CONTAMINATED WATER PIPING REPLACEMENT

**HEBRON ELEMENTARY SCHOOL
92 CHURCH STREET
HEBRON, CT 06248
STATE PROJECT NO. 067-0042 CV
BID #2020-03**

S/P+A PROJECT NO. 19.003

DATE: November 15, 2019

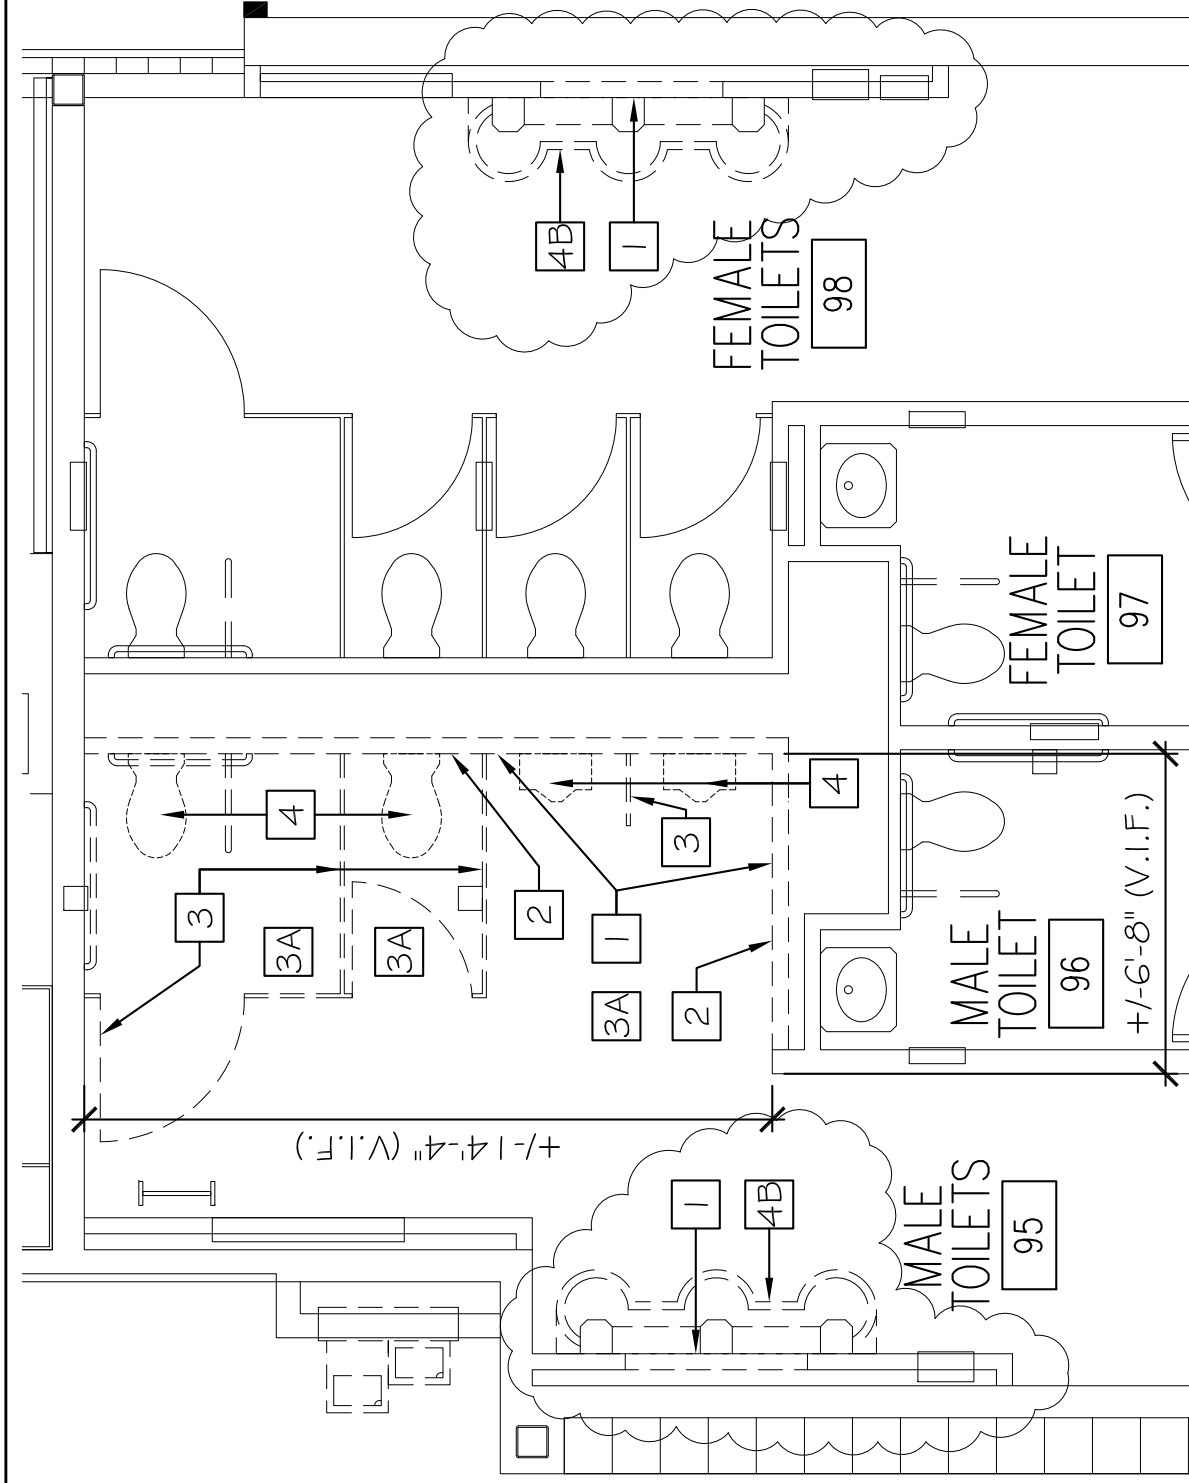
1. If we plan on removing the entire wet wall in the bathrooms to access the plumbing behind, can we rebuild the wall using CMU rather than brick? (I believe the only location where the existing wall is brick is in bathroom 08 – Male Toilets.) Please advise.

S/P+A Response: Yes, if the Contractor removes the entire existing brick masonry wall construction at the Male Toilet 08 side of the plumbing chase between Male Toilet 08 & Female Toilet 09, it is acceptable to provide Wall Type “A” when rebuilding the wall. If only a portion of the existing brick masonry plumbing chase wall is removed at Male Toilet 08, all of the existing ceramic tile wainscot located on the chase wall must be removed and replaced with new ceramic tile wainscot. Please refer to the forthcoming Addendum #6 for additional information.

Drawing Title:
Toilet Rooms 95 & 98
Enlarged Plans

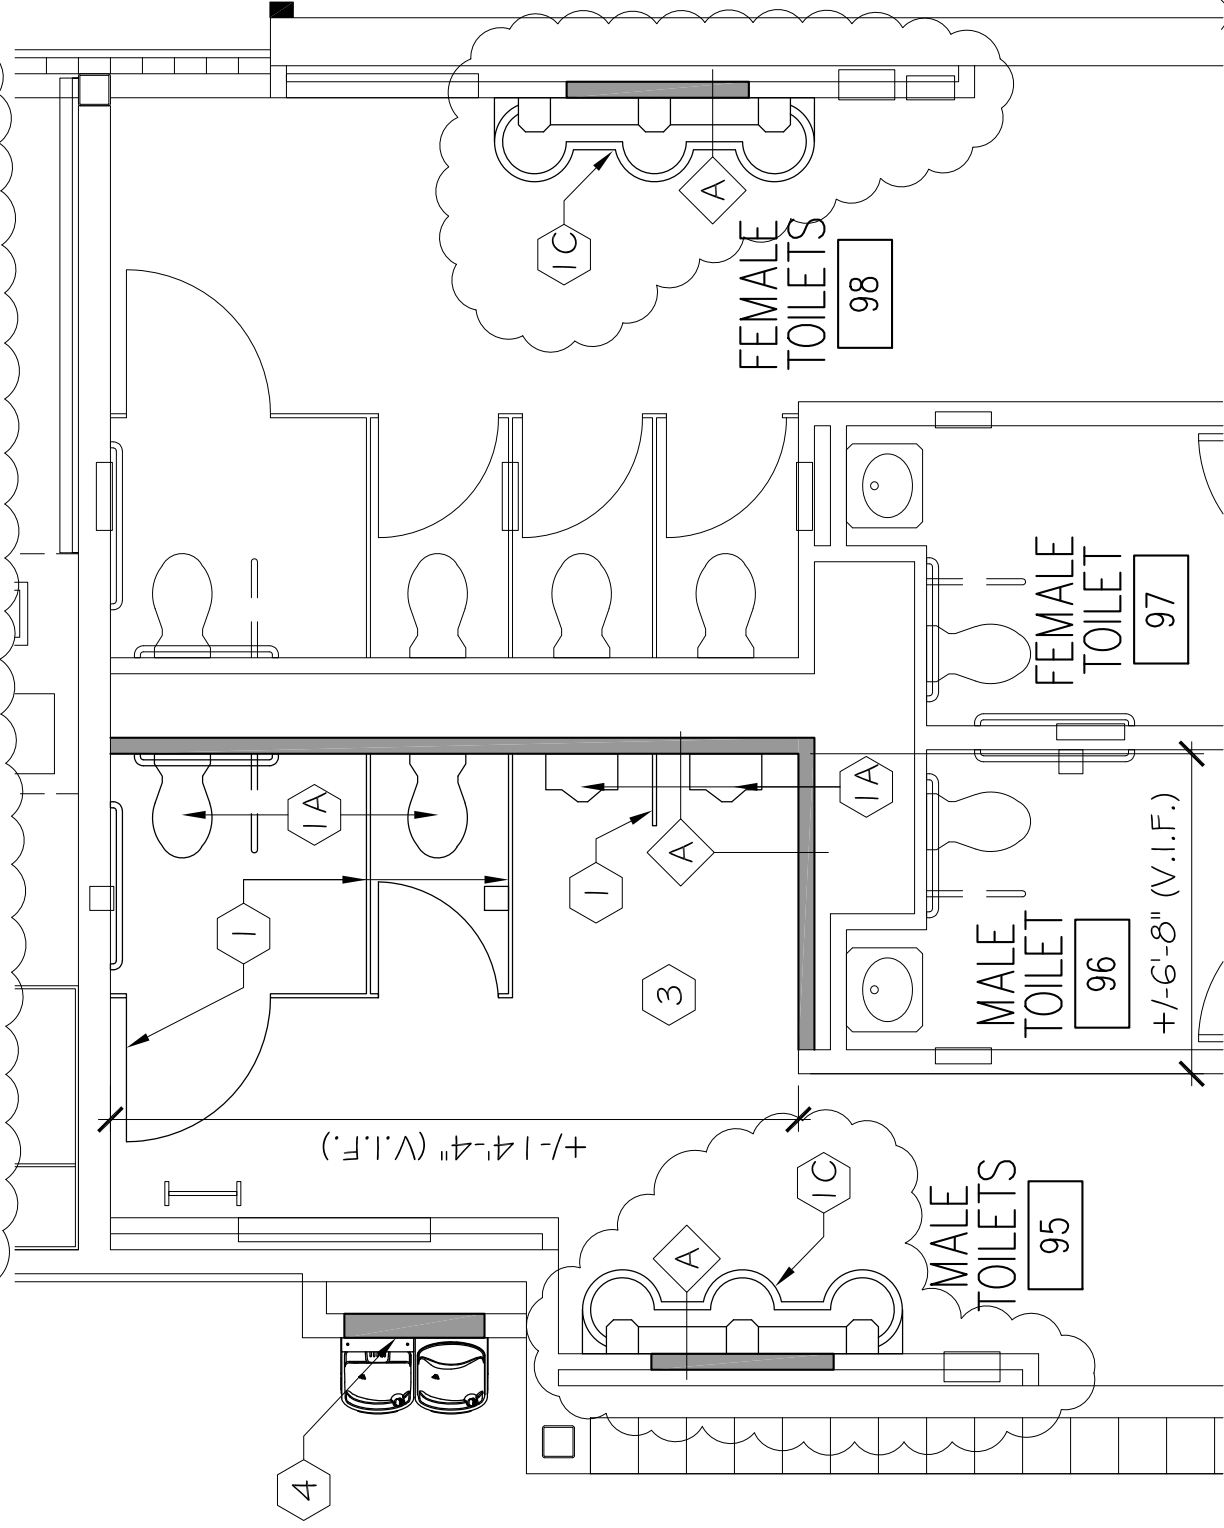
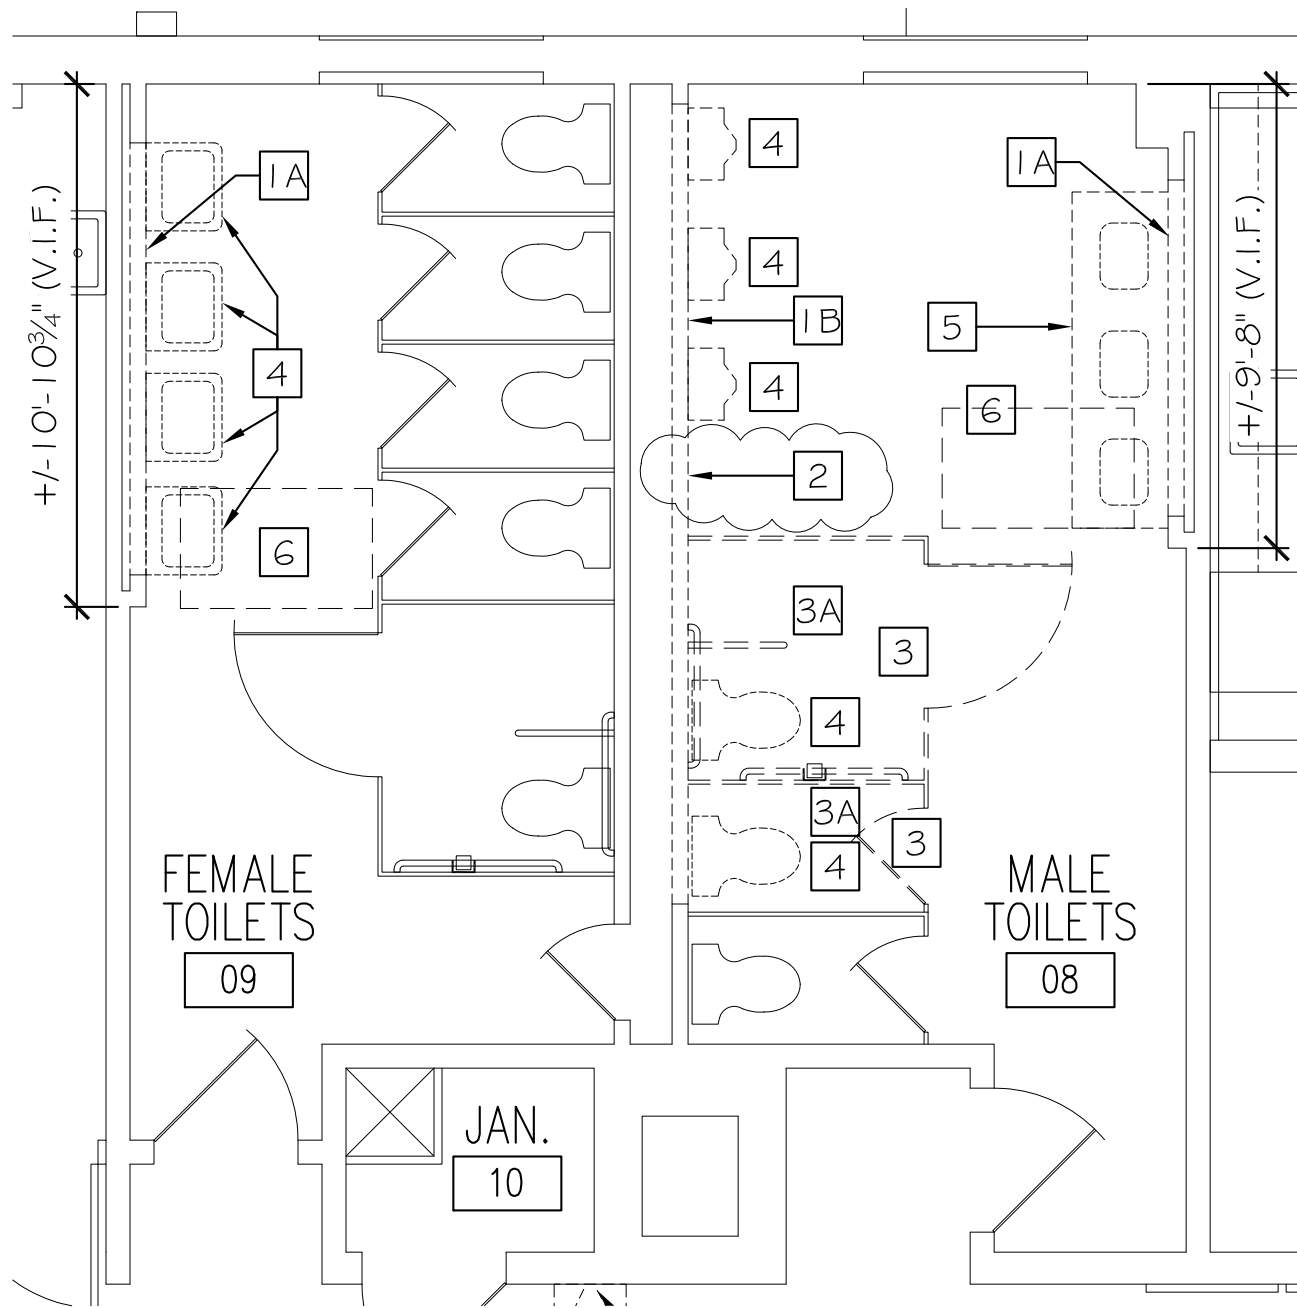
- 2) The new water lines to the above mentioned Bradley sinks appear to be shown dropping in solid walls, what is the proposed method to supply these sinks? No masonry work is shown on the architectural drawing A101 detail 1 and 2.

S/P+A Response: Based on available as-built documents and review of the site conditions, the wall construction behind each of the Bradley sinks in question consists of 4" CMU block with a 4" chase space beyond to run the new supply piping from above. Contractor is responsible for selective demolition & patching of the existing chase wall construction behind the new Bradley unit as required to run the new piping, please refer to forthcoming sketch to clarify scope of work.

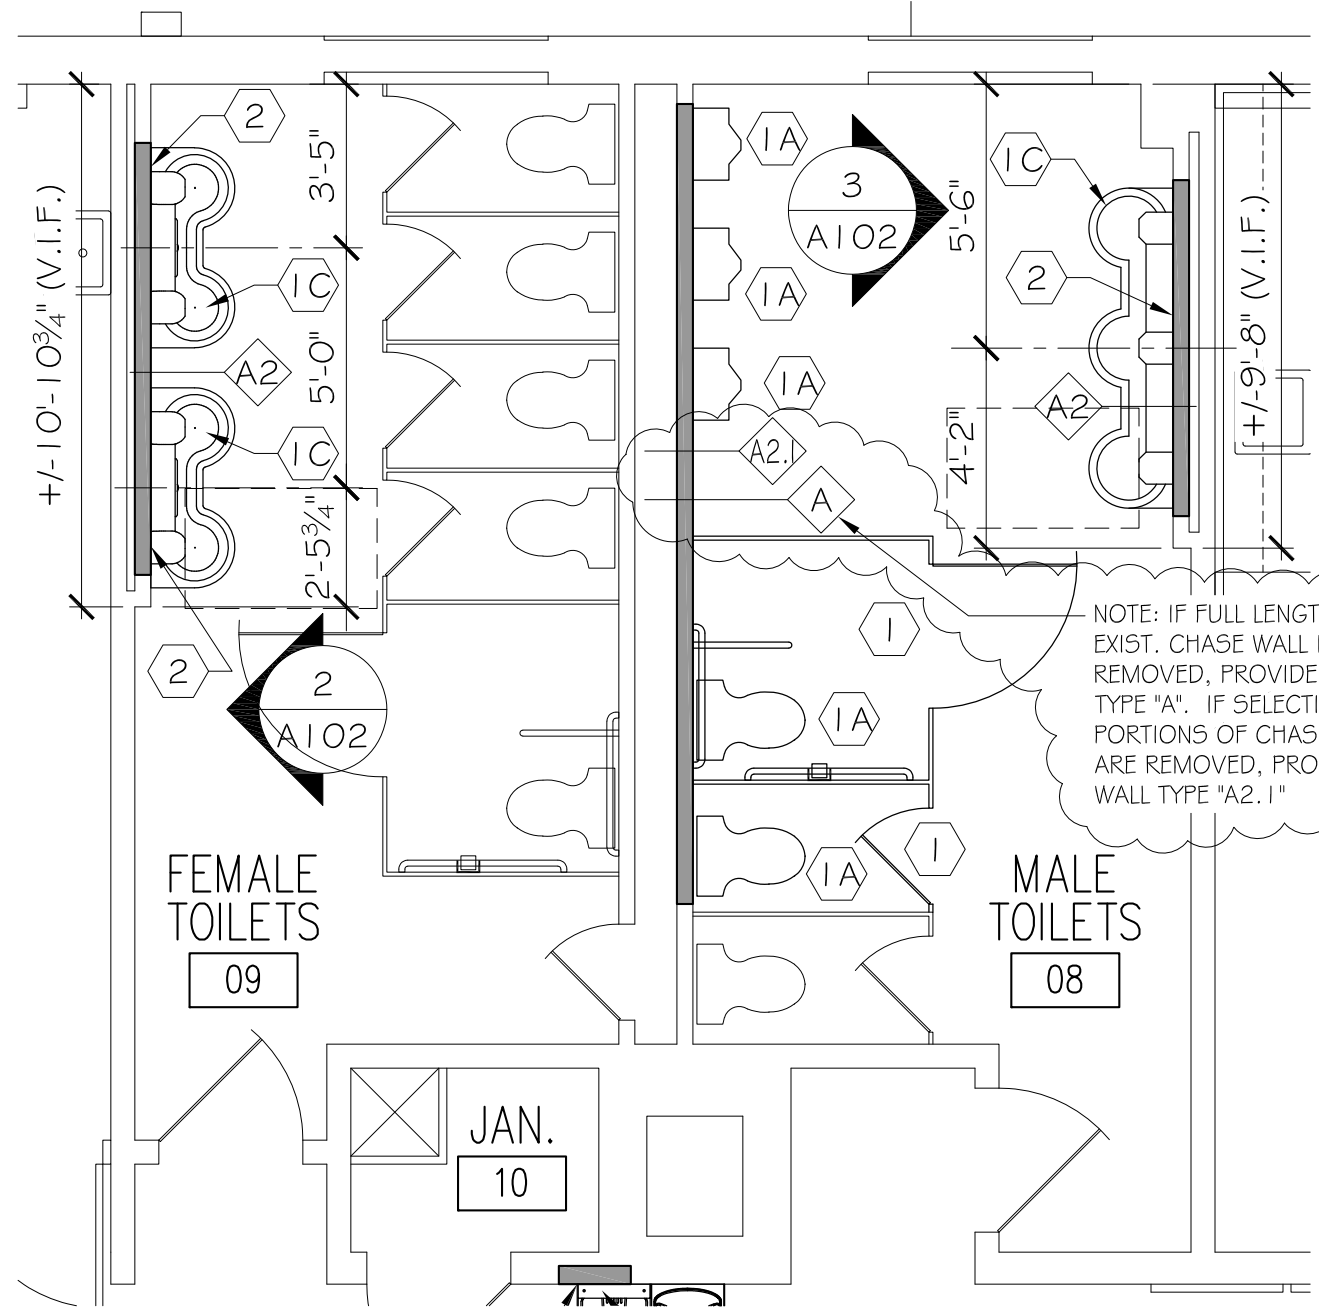
The brick in existing bathrooms 8 & 9 is 3.25" x 11". Several masonry vendors have not been able to source brick of this size. According to wall type A2 on G0001 we are to match existing. Please advise if an alternate available size brick is acceptable.

S/P+A Response: Provision of alternate sizes of brick masonry units that are close in modular size to the existing brick units is acceptable as long as they are provided in an inconspicuous manner and blend well with the adjacent existing-to-remain masonry units. Salvaging and reuse of existing brick units to the greatest extent possible is encouraged.

NOTE: IF FULL LENGTH OF EXIST. CHASE WALL IS REMOVED, PROVIDE WALL TYPE "A". IF SELECTIVE PORTIONS OF CHASE WALL ARE REMOVED, PROVIDE WALL TYPE "A2.1"
